Friday, 6 February 2015

RE: Submission – Barangaroo Ferry Hub / Barangaroo Ferry Terminal (SSI- 6727)

Figure 3 - Noise catchment areas and monitoring locations excerpt (EIS 2014)

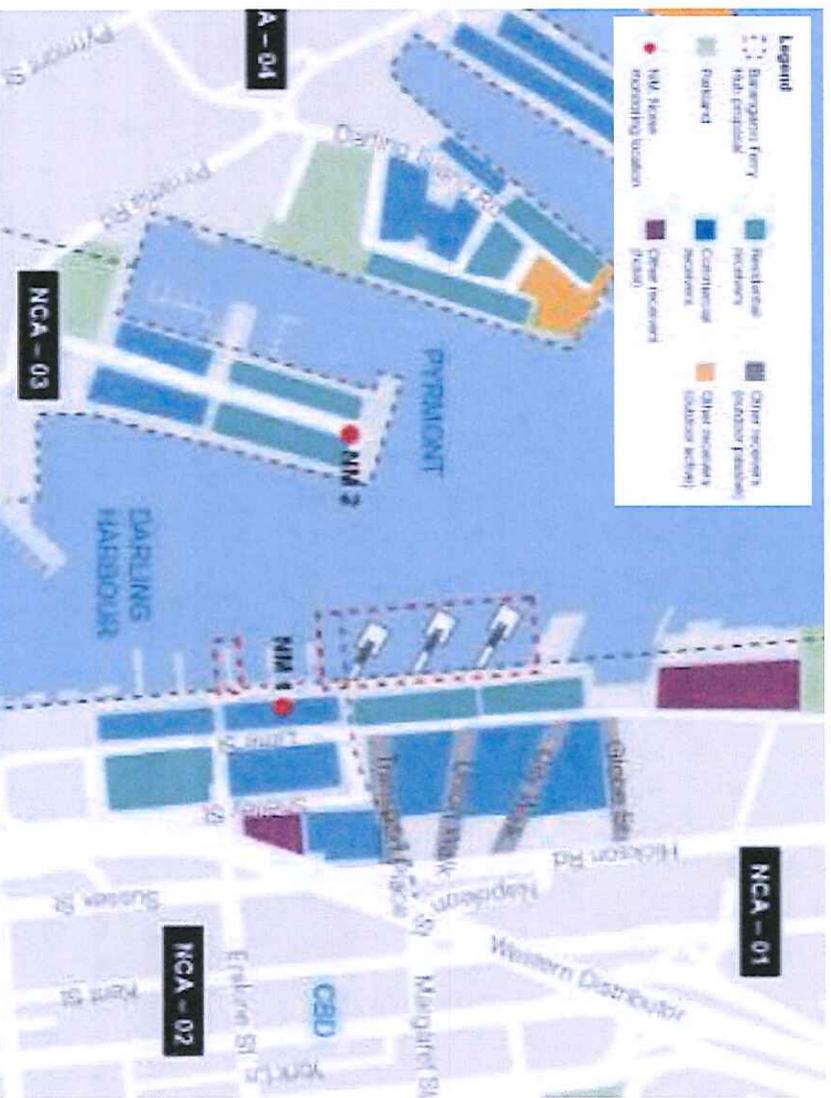
Construction works have commenced on Commercial Buildings C3, C4 and C5, and Residential Buildings R8 and R9 at Barangaroo which are located adjacent to the public promenade adjacent to the proposed ferry wharves. The two buildings closest to the promenade include Residential Building R8 and R9, which were approved under MP11_0002. As demonstrated at Figure 3, the proposed wharves are located in closer proximity to sensitive receivers compared to the existing King Street Ferry Wharf.

We consider it a sensible approach to cluster wharf activity around existing and planned commercial uses where maritime impacts are already established. It is noted that during the construction or operation of the proposal no 'moderate impact' or 'high impact' exceedances are anticipated within the King Street Wharf noise catchment area (NCA-02) during standard or outside standard hours. This is supported within the proposal, and Brookfield encourage any changes that are made to the proposal as a result of the response to submission maintain this limited disturbance to the precinct.

Despite this, significant exceedances including sleep disturbances are anticipated for the future Barangaroo noise catchment area (NCA-01), Pyrmont (NCA-03) and Pyrmont and Jones Bay Wharf (NCA-04) during the construction and operational phases of the development.

The EIS states that "a Construction Noise and Vibration Management Plan (CNVMP) will be included in the CEMP" to provide the framework for noise mitigation during the construction works. The proposal does not offer however significant mitigation methods for the proposed operational acoustic impacts of the proposal. We commend that this is addressed within the conditions of approval, and further emphasises the construction of the two southern wharves rather than the most northern wharf.

Figure 3 - Transport Square for Discussion (TfNSW, Barangaroo Integrated Transport Plan 2012)

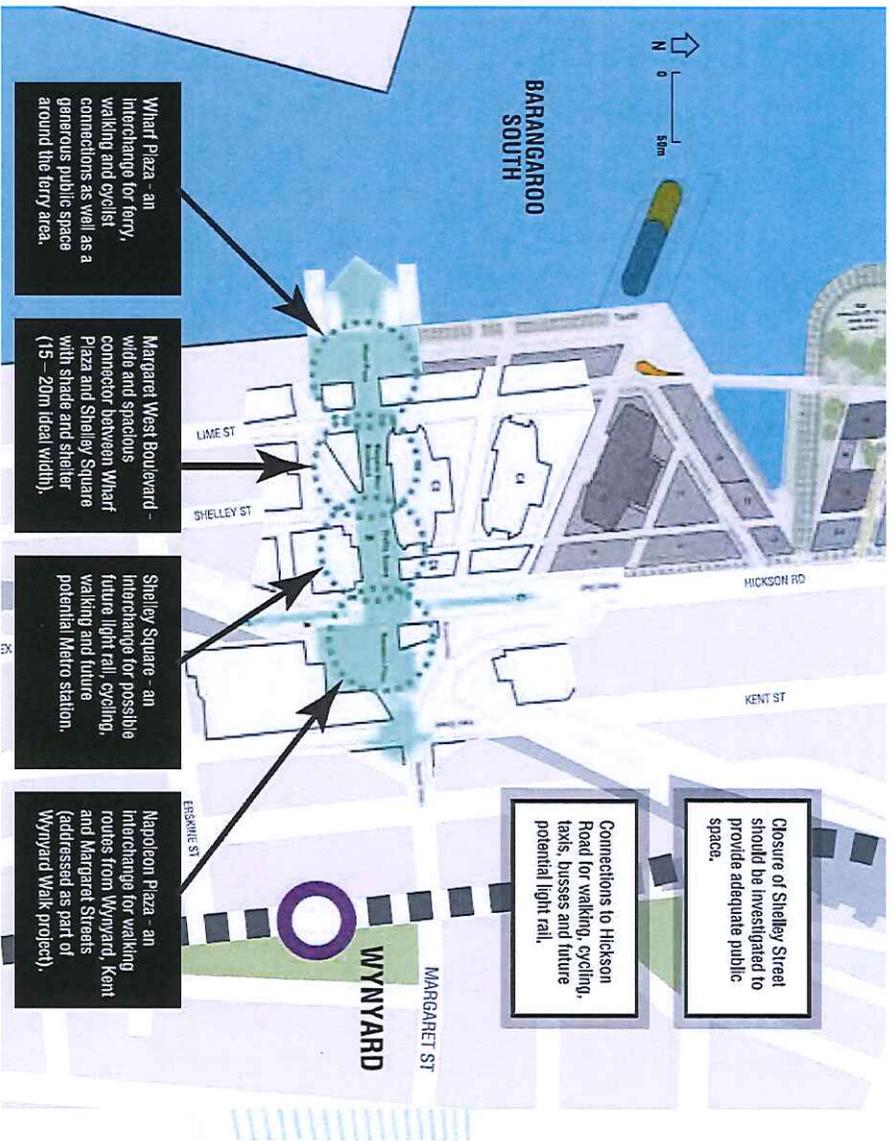
The Barangaroo Integrated Transport Plan (2012) supports the development of a Transport Square at Barangaroo. This concept of connecting Wynyard Station to the Barangaroo Ferry Wharf has been integrated within the planning of Barangaroo South notably through the provision of 'Transport Place', between the two southern ferry wharves proposed at Barangaroo. Notably, the Wynyard Walk Bridge will provide a direct connection from Wynyard Walk to Transport Place. This is clearly illustrated on page 139 of the EIS, outlined within the anticipated pedestrian movements illustrated on page 152 of the EIS, and within the Barangaroo Integrated Transport Plan as demonstrated within Figure 3 on the next page.

A State Significant Development Application is currently being assessed by the Department of Planning and Environment for the construction of Stage 1A public domain works, including the construction of Transport Place. As such, it is considered prudent to construct the first two of the wharves at the intersection of Transport Place to provide a direct connection not only to King Street Wharf but also to Wynyard Walk. This is further discussed in Section 2.2 of this submission.

Figure 4 – Way-finding Strategy (EIS Attachment)

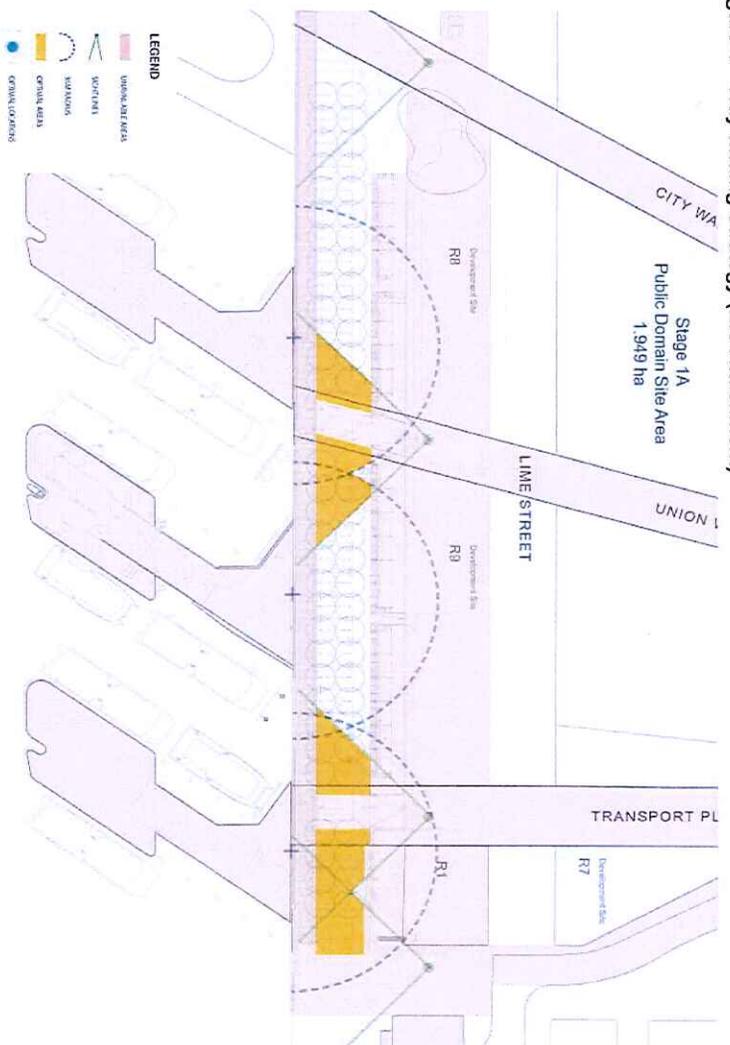
Despite this assertion within the EIS, the proposal has not adequately considered this within the way-finding plan or another strategy. Further, as shown in Figure 4, the way-finding plan has been drafted with consideration of arriving at the site through Barangaroo only, rather than from properties to the south.

Brookfield seek to confirm from the proponent and the Department of Planning and Environment that the proposal will not result in the ‘funnelling’ of pedestrians through Barangaroo at the expense of visitors to King Street Wharf and Darling Harbour.

In response to the above items we request that a way-finding strategy is provided by the proponent as part of this application which clearly considers and accommodates additional signage and way-finding imagery not only to development at Barangaroo, but also to existing and future development to the south.
